## **Groenenbergterrein Safeguarding Study**

Document title	Groenenbergterrein – Safeguarding Study
Author	M Wills, Cyrrus Associates Limited
Produced by	Cyrrus Associates Limited Canberra House First Avenue Doncaster Sheffield Airport DN9 3GA Tel: +44 (0)1302 802223 Fax: +44 (0)870 762 2325
Produced for	Chipshol Boeing Avenue 250 1119PZ Schiphol Rijk The Netherlands
Cyrrus Associates contact	B J R Hawkins Tel: +44 (0)7810 811534 Email: <a href="mailto:bjrhawkins@cyrrus.co.uk">bjrhawkins@cyrrus.co.uk</a>
Produced under contract	
Version	Final
Date of release	28 <sup>th</sup> November 2006
Document reference	CA/4212/R1

Planning permission for the development of the Groenenbergterrein by Chipshol has been opposed by LVNL on the basis of interference with the Instrument Landing System Glidepath facility serving runway 36R at Amsterdam Schiphol airport. Cyrrus Associates Ltd has carried out an independent evaluation of the impact of the development on behalf of Chipshol and assessed the basis of the objections raised by LVNL.

Figure 7 Cyrrus Associates validation of LVNL assessment.

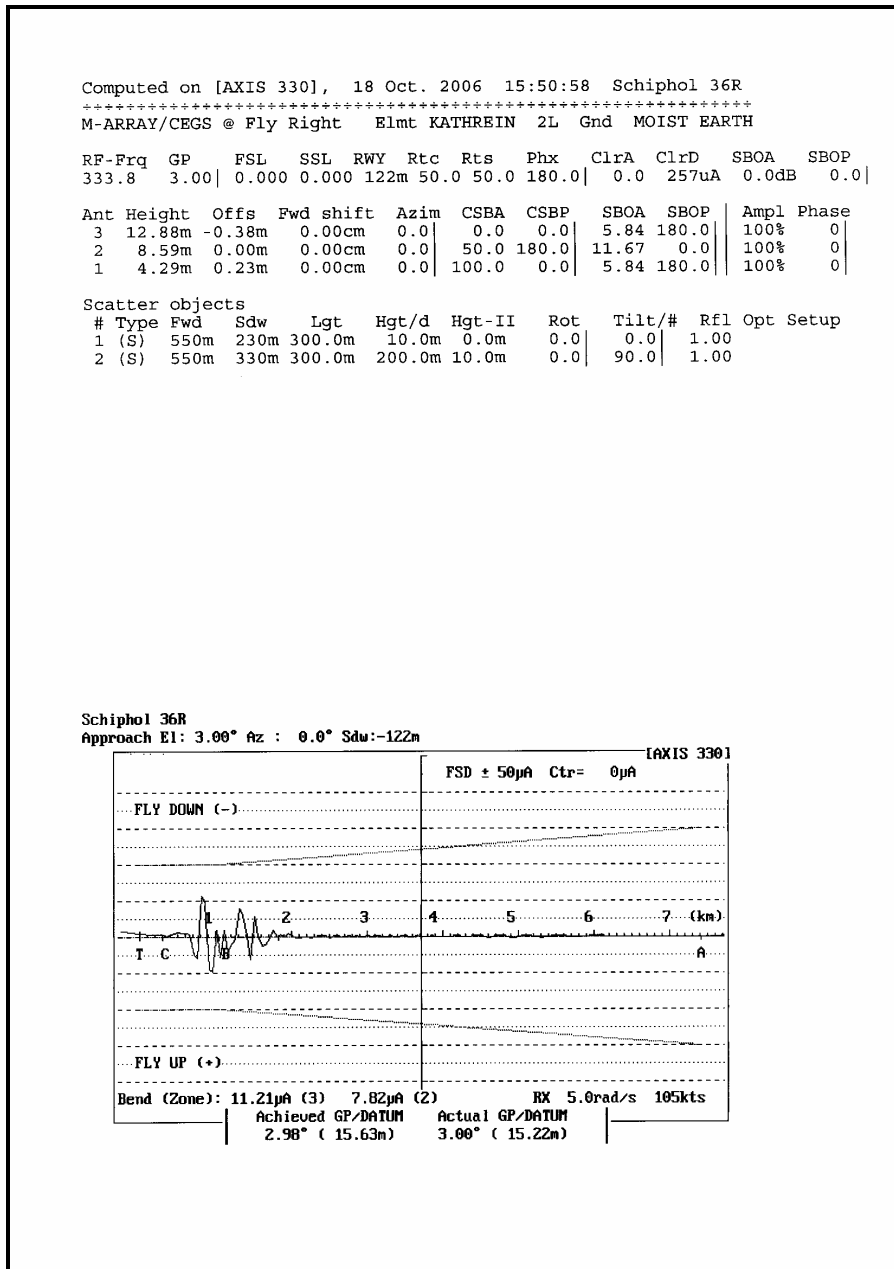
5.2.5 The output of the model in both cases is identical. Having established that the modelling is the same, the assumptions made in the LVNL model are now analysed.

Figure 8. LVNL ILS Model

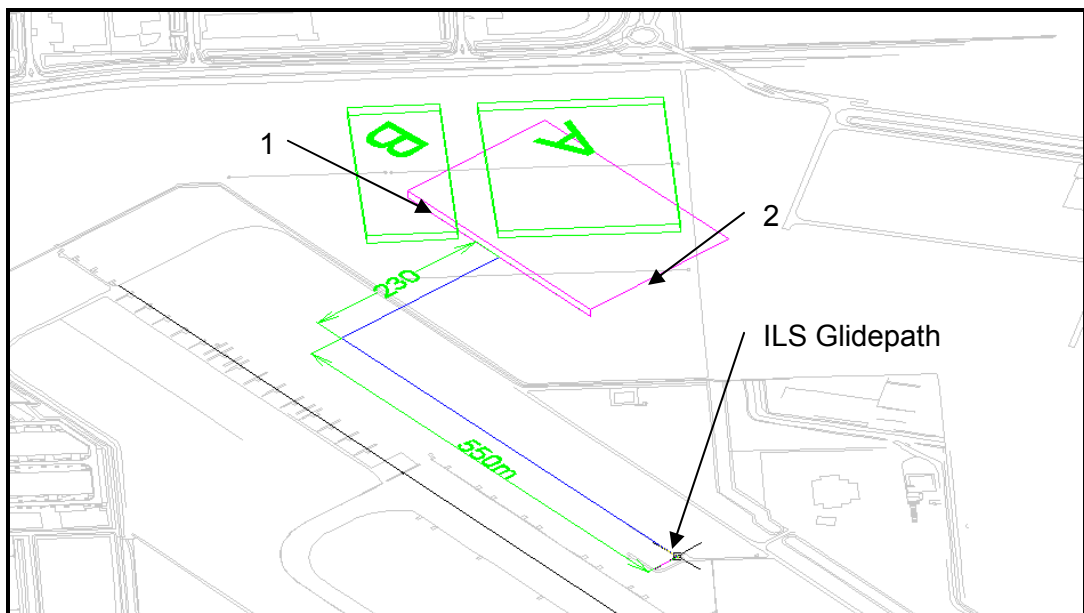
5.3.2 Figure 8 illustrates the configuration of the LVNL model. The magenta object is that modelled by LVNL in the AXIS simulation. The LVNL model represents the face of a metal clad building, 300m long and 10m high, parallel to the runway, with the roof of the building which is 200m wide. The structure as modelled infringes on land that is outside of the Groenenbergterrein. Areas A and B are shown for reference.

Figure 13. LVNL simulation with 2 Rad/s filtering.

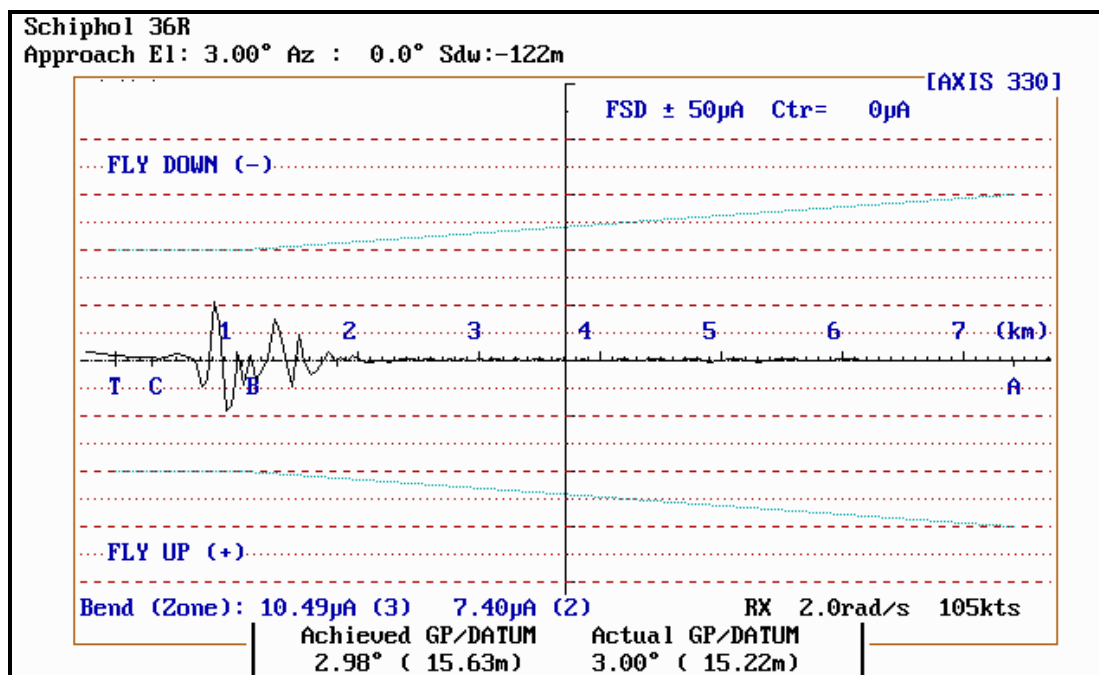
- 5.4.5 One further area identified where the LVNL model is considered unrealistic is the choice of receiver damping factor used. All ILS receivers incorporate damping of the deviation output to prevent noise affecting the aircraft flight control systems. The receiver damping factor is stated in Attachment C to part I of ICAO Annex 10<sup>[1]</sup> as a time constant which is a function of aircraft approach speed. The implementation of the receiver filter in AXIS 330 is quoted in radians per second (rad/s). The LVNL simulation utilised a default receiver damping filter coefficient of 5 rad/s, which is much less than the ICAO recommendation which is approximately 2 rad/s.<sup>[4]</sup> As a consequence, the LVNL model predicts beam bend amplitudes which are greater than would be seen by users. By comparing the results of the two filters, the LVNL result is around 7% higher than would typically be seen by users. See Figures 9 and 13.

Figure 17. Result of modified worst-case model.

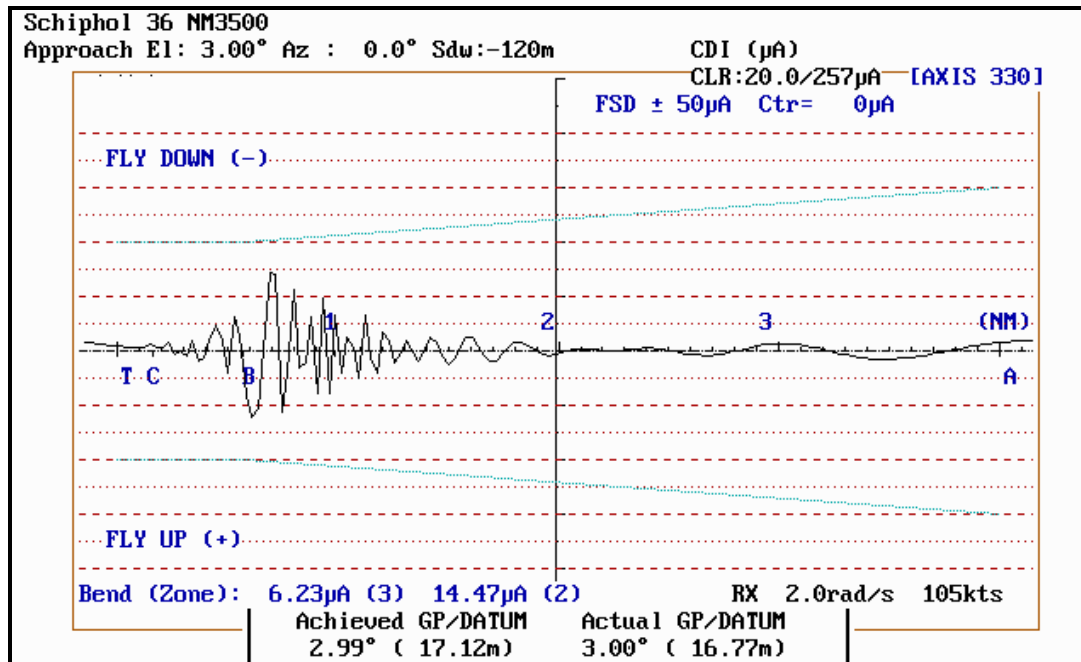
- 5.6.5 It can be seen by comparison with Figure 13 that buildings closer to the boundary of the Groenenbergterrein have a greater effect than that modelled by LVNL. In this instance, the refined worst-case model shows greater degradation of the ILS than was predicted by the LVNL assessment. This raises some concerns in that the LVNL worst-case model did not sufficiently identify the degree of degradation on the ILS which could have subsequent safety implications to users of the ILS facility. It should be noted that this worst-case scenario is not intended to represent the Chipshol plan, but rather to determine the maximum disturbance that development on the GBT could cause.

Figure 18. GBT813bl01 Truck Parking

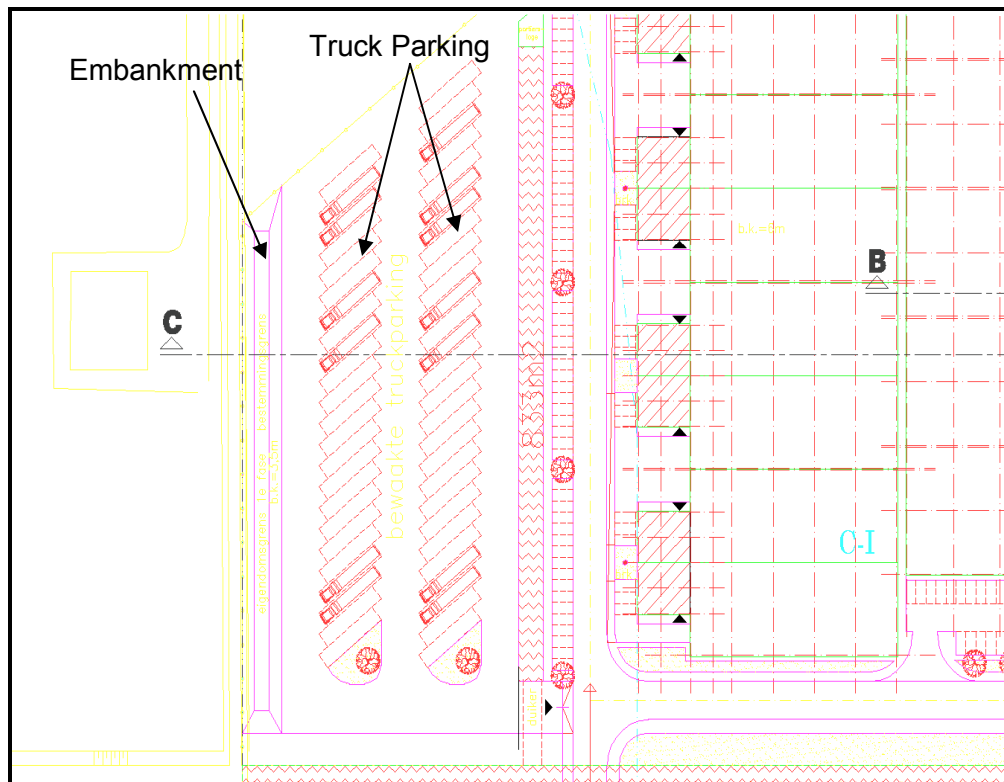
- 6.2.5 As Figure 19 shows, the embankment provides screening of the trucks and part of the building, yet it is not clear if this was accounted for in the model.

- 6.2.6 Using a generic model, the main contribution from the trucks comes from B' in Figure 20, which is nearly parallel to the runway. If this was the case, why was the orientation of the truck parking not altered to reduce this?

Figure 20. NLR report Appendix A

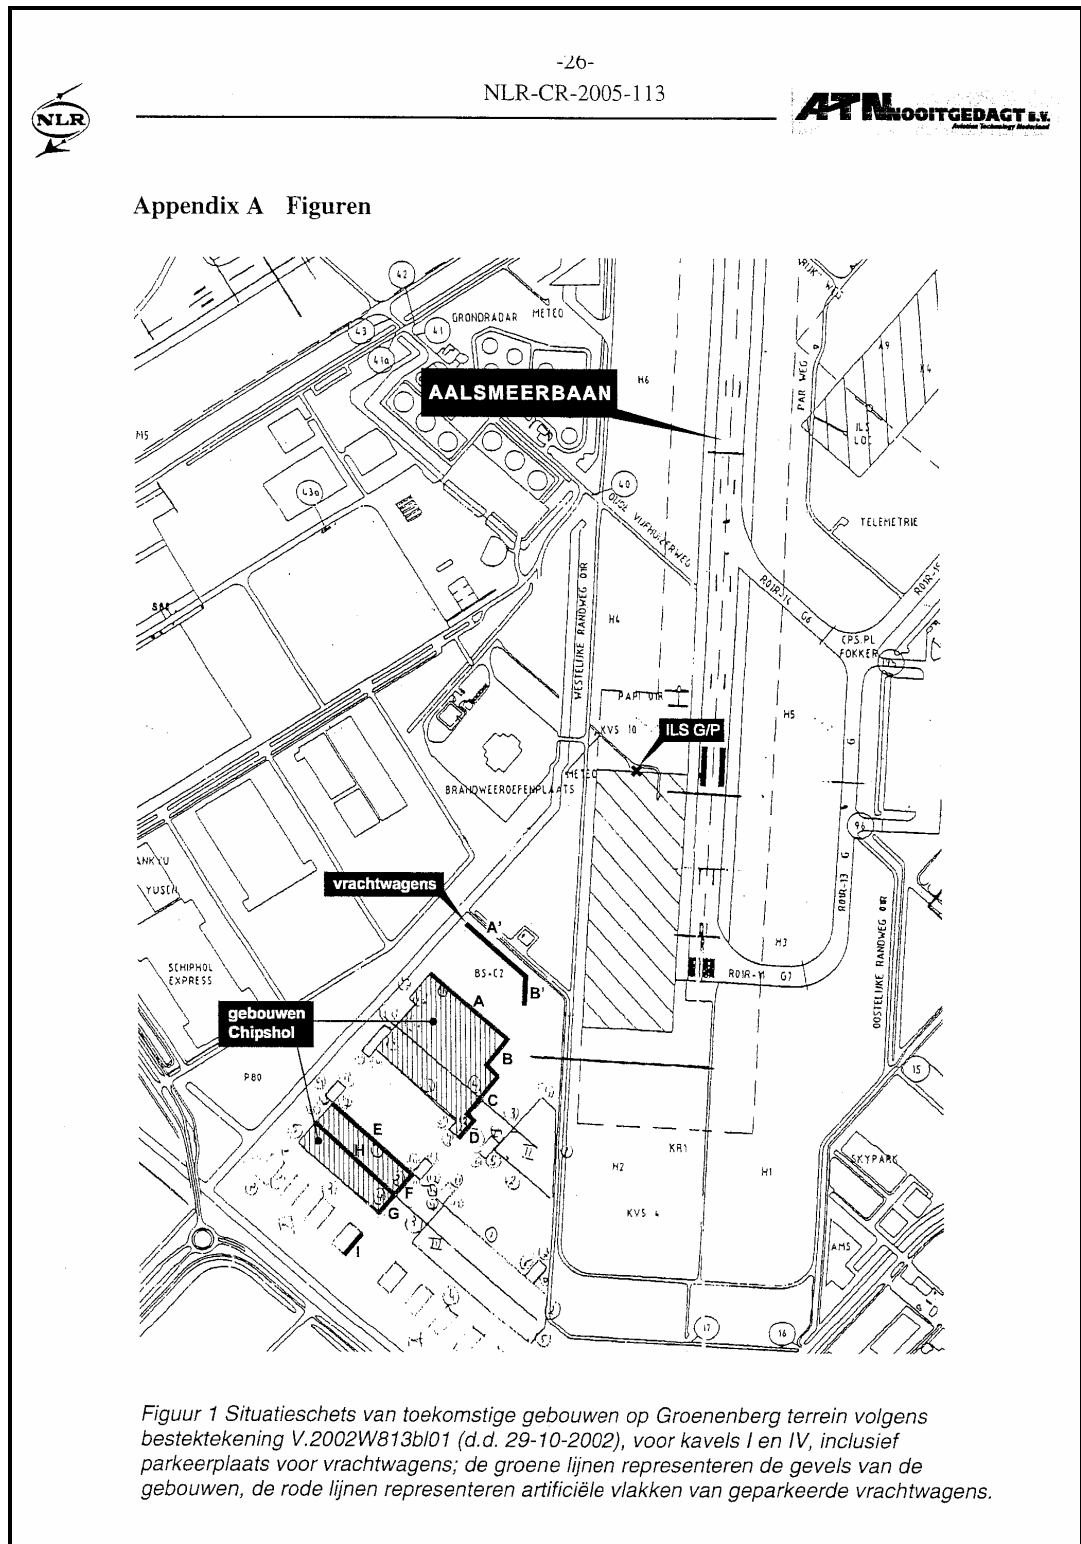
6.2.3 The following observations are made based on Figure 20: The major contribution to glidepath bends was determined to come from the truck parking (A' and B' in Figure 20). From interpretation of the drawing, there is a 3.5m earth embankment between the majority of the truck park and the ILS (Figure 19) which serves to provide screening of the trucks and part of the building. It is not clear if this was allowed for in the modelling.

- 6.2.7 As stated in section 3.6, only those aspects of the building illuminated by the ILS signal are modelled. Items B, C, D, F, G and I in Figure 20 do not appear to be directly illuminated and yet are identified on the plan.

Figure 56a. Truck parking not parallel to runway.

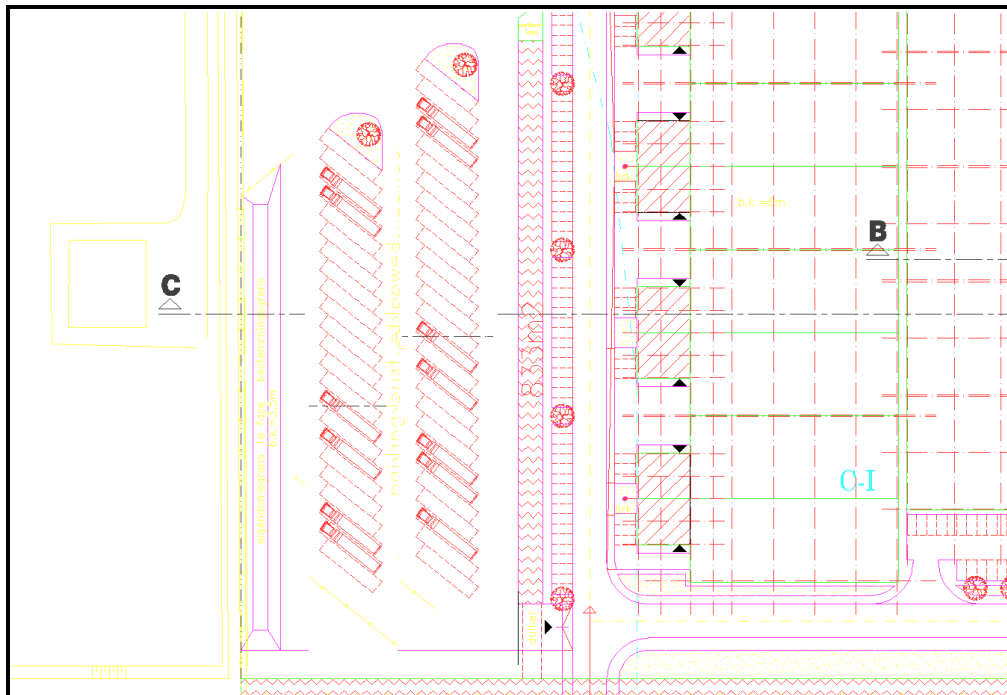
- 7.7.6 From the modelling carried out, the concerns raised over the truck parking by LVNL are overstated. The figures derived from the simulation, whilst being higher than desirable, are within the limits quoted by LVNL. For further analysis of Error Budgets, see section 7.10.
- 7.7.7 The problem with the truck parking is mainly due to the trucks being parallel with the runway. This could be overcome either by changing the orientation of the truck parking such that the trucks do not park parallel with the runway as per figure 56a, or by screening the truck park as discussed in section 7.5.

Figure 58. Areas A&B – Isometric View – LVNL model shown in Magenta.

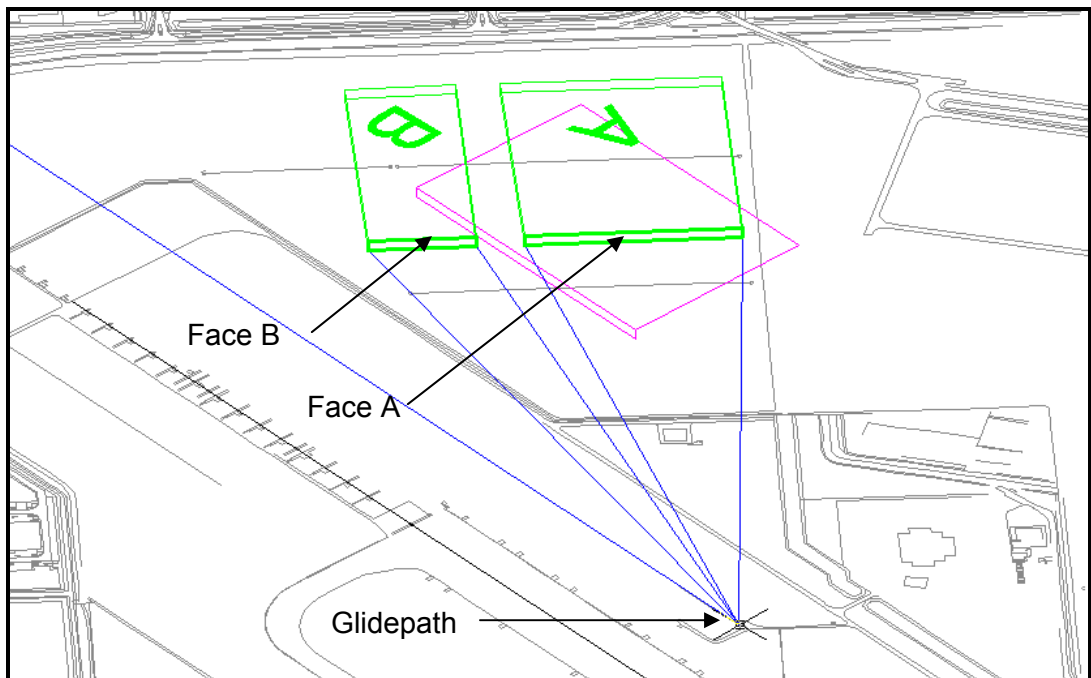
7.8.2 Figures 57 and 58 show areas A and B represented in green on a drawing of the Airport. The original LVNL simulation is shown as the magenta object in Figure 58. The distances of the faces of typical buildings relative to the glidepath were derived from the drawing and entered into the AXIS simulation.

Figure 66. Areas A&B with LVNL Glidepath model overlaid.

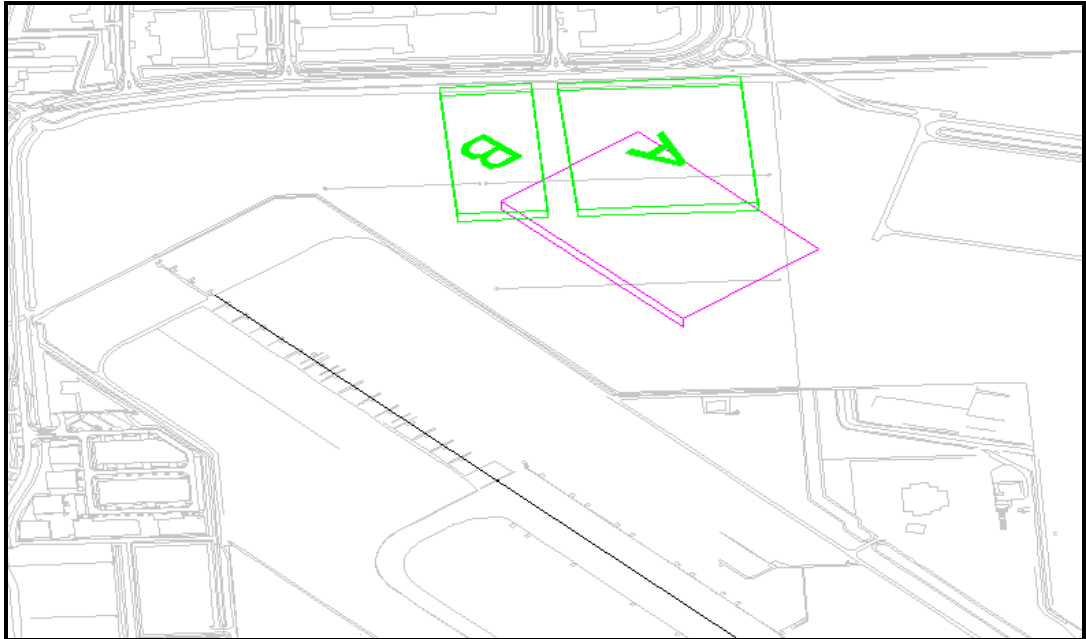
7.9.5 The areas A and B relative to the original LVNL glidepath model are depicted in Figure 66. The LVNL model is not considered representative of construction in areas A and B.
